Z-57
(2014)

Zoning Application Survey for FERNANDO FUNES
Marietta, Georgia
Land Lot: 279 District: 17th 2nd Section
Cobb County, Georgia

PETITION NO: Z-57
HEARING DATE (PC): 08-05-14
HEARING DATE (BOC): 08-19-14
PRESENT ZONING: LI, GC
PROPOSED ZONING: CRC

ZONING COMMENTS:

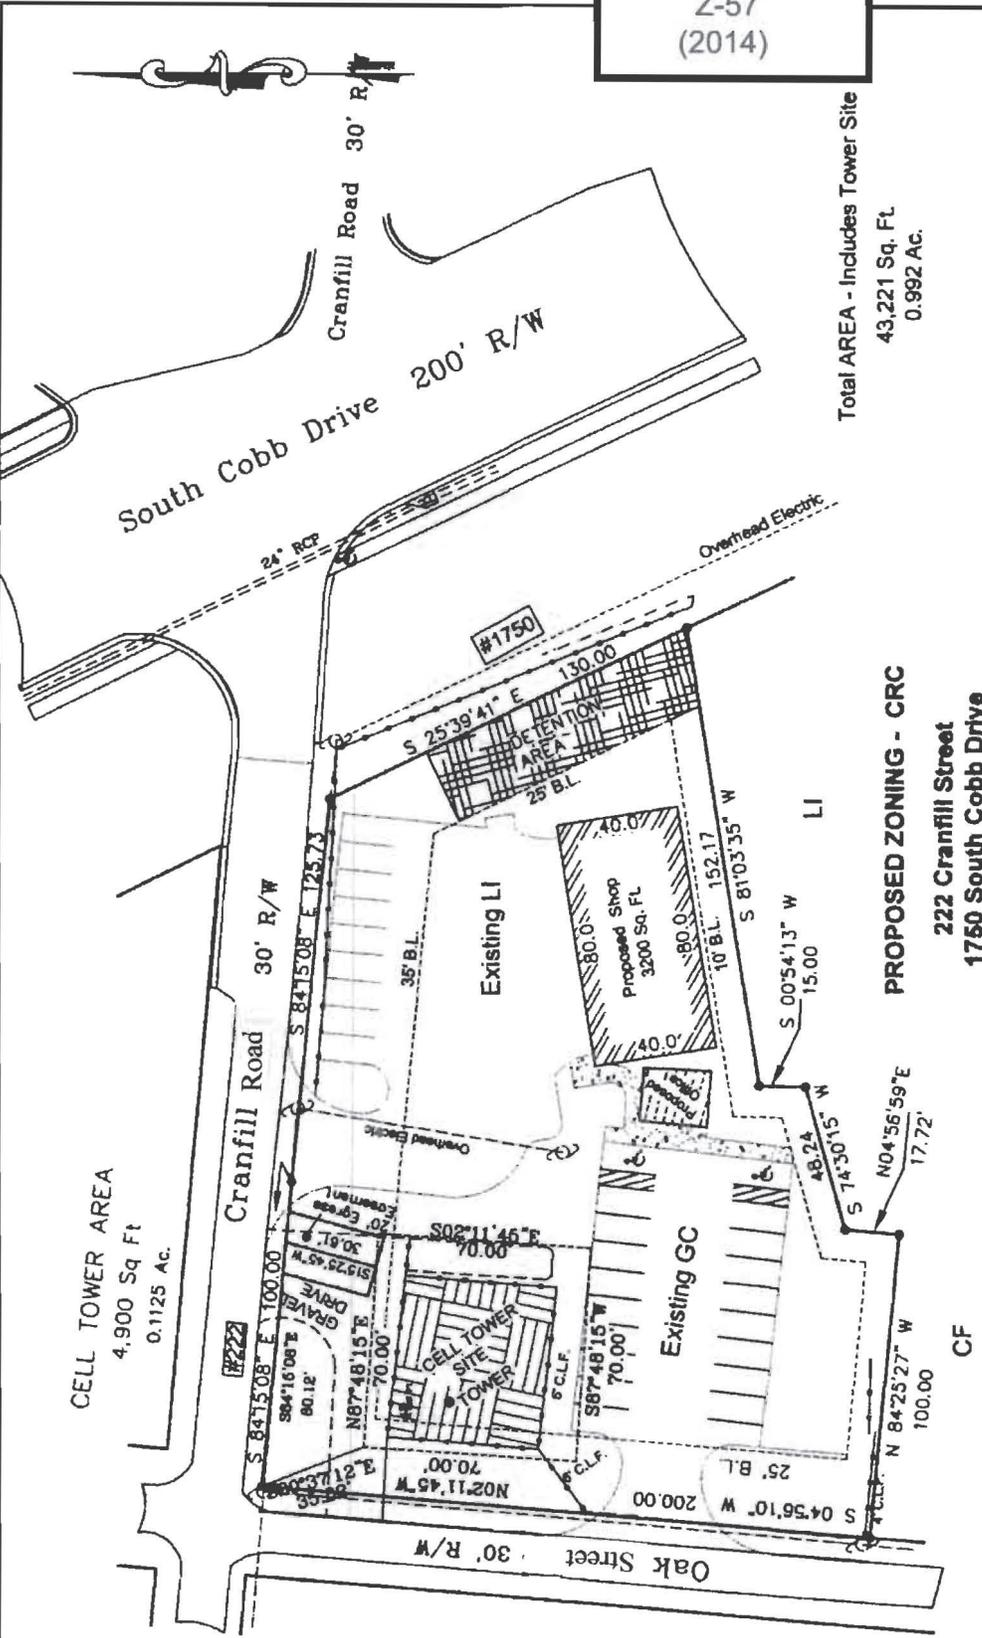
- No Stormwater controls shown _____
- Copy of survey is not current – Additional comments may be forthcoming when current site conditions are exposed.
- No site improvements showing on exhibit.

1. All site runoff must be directed to the proposed detention facility. The detention pond must be designed to tie directly into the existing stormwater system with the right-of-way.

Cranfill Road is classified as a local and according to the available information the existing right-of-way does not meet the minimum requirements for this classification.

Oak Street is classified as a local and according to the available information the existing right-of-way does not meet the minimum requirements for this classification.

Recommend applicant consider entering into a development agreement pursuant to O.C.G.A. 36-71-13 for dedication of the following system improvements to mitigate traffic concerns: a) donation of right-of-way on the south side of Cranfill Road, a minimum of 25' from the roadway centerline.

Recommend applicant consider entering into a development agreement pursuant to O.C.G.A. 36-71-13 for dedication of the following system improvements to mitigate traffic concerns: a) donation of right-of-way on the east side of Oak Street, a minimum of 25' from the roadway centerline.

Recommend no access to South Cobb Drive.

Oak Street is a substandard street. Recommend improving Oak Street from proposed driveway to the intersection with Cranfill Road to comply with Cobb County Development Standards if access is permitted.

- REVISED site plan received by the Zoning division on June 12, 2014, with the District Commissioner approving minor modifications;
- All repairs to be done inside building;
- No outdoor storage or outdoor displays;
- No junk cars kept on site;
- No access to Oak Street;
- 20-foot landscape buffer along Oak Street;
- Water and Sewer Division comments and recommendations;
- Stormwater Management Division comments and recommendations;
- Department of Transportation comments and recommendations; and
- Owner/developer to enter into a Development Agreement pursuant to O.C.G.A. §36-71-13 for dedication of system improvements to mitigate traffic concerns.
